Point Beach Nuclear Plant, Units 1 and 2
Dockets 50-266 and 50-301
Renewed License Nos. DPR-24 and DPR-27

License Amendment Request 241
Alternative Source Term
Response to Request for Additional Information

LICENSE AMENDMENT REQUEST 241 ALTERNATIVE SOURCE TERM RESPONSE TO REQUEST FOR ADDITIONAL INFORMATION

BECHTEL 6118 M-1
 WESTINGHOUSE ELECTRIC CORPORATION
 WESTINGHOUSE MICHIGAN POWER COMPANY
 UNIT 1 EQUIPMENT LOCATION - PLAN
 MUSELLANDS UPPER FLOORS SOUTH
 35330
 18 SHEET E

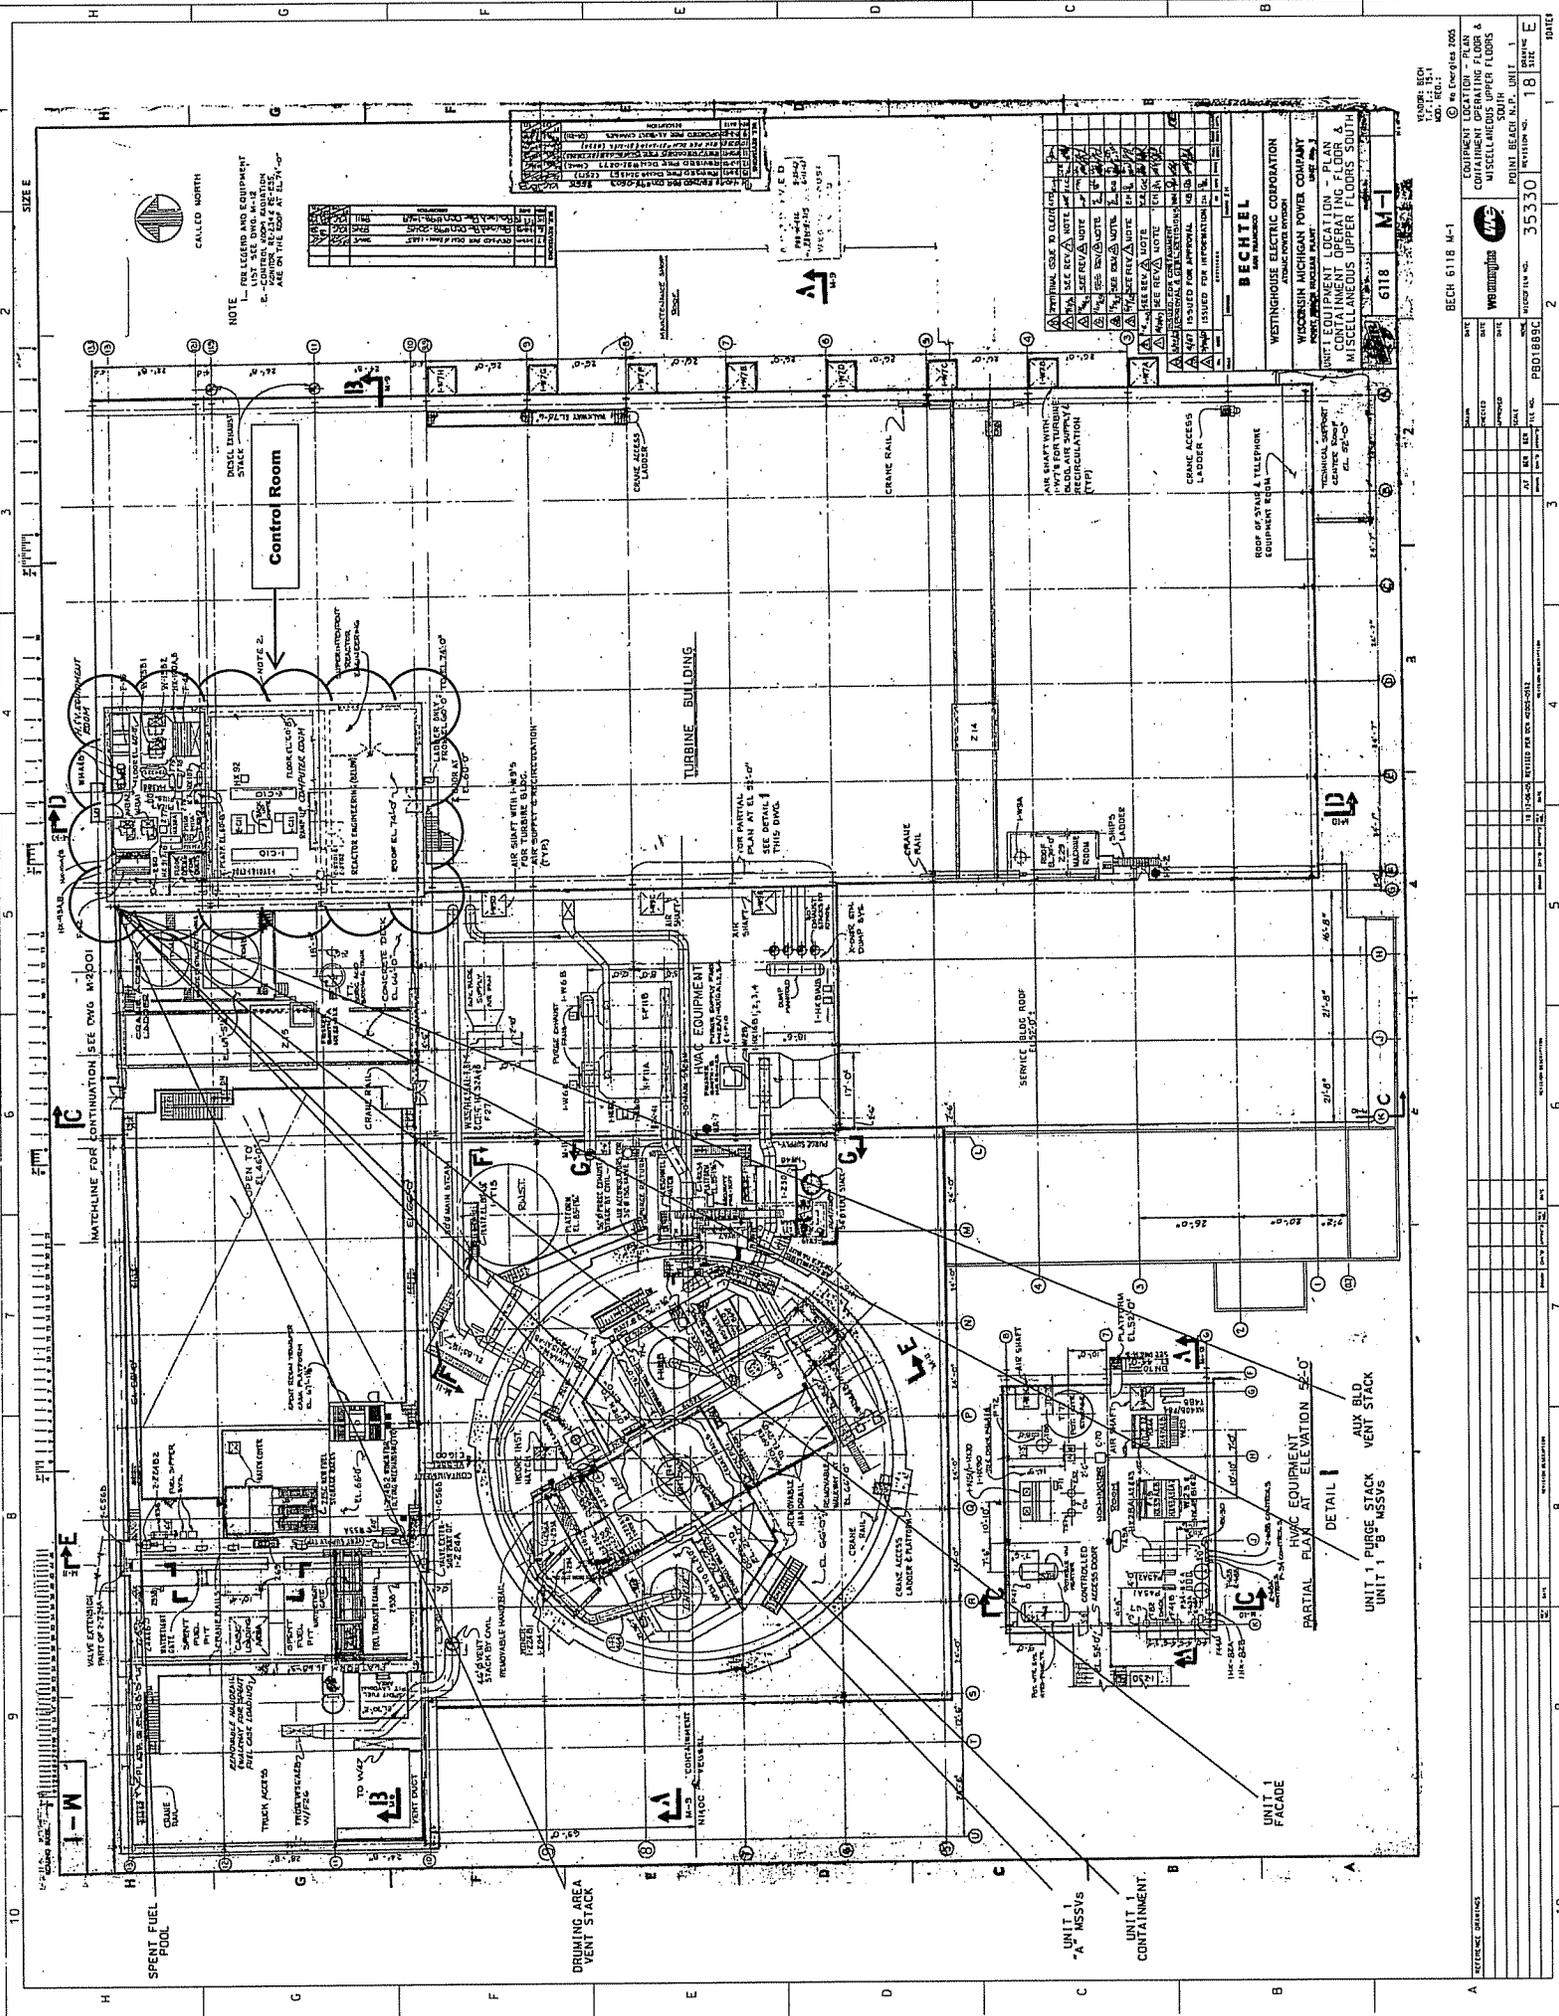
Please provide a further discussion of why it is acceptable to use the control room atmospheric dispersion factors (χ/Q values) for dose estimates associated with unfiltered inleakage into the control room envelope. Where is the control room located with respect to the postulated release locations shown in the figures provided as part of the December 8, 2008, LAR?

For the control room χ/Q calculations, the receptor is the control room fresh air intake for each release location. This receptor location is also used for unfiltered inleakage. The source-to-receptor distance was determined by the shortest horizontal distance between the release points and the control room air intake. This approach is consistent with Section 3.4 of RG 1.194 (Reference 5).

The detailed plant drawings used in the limiting χ/Q calculations are included in Enclosure 3. Drawings M-1 and M-2001 in Enclosure 3 show the locations of the control room with respect to the postulated release locations for Unit 1 and Unit 2, respectively.
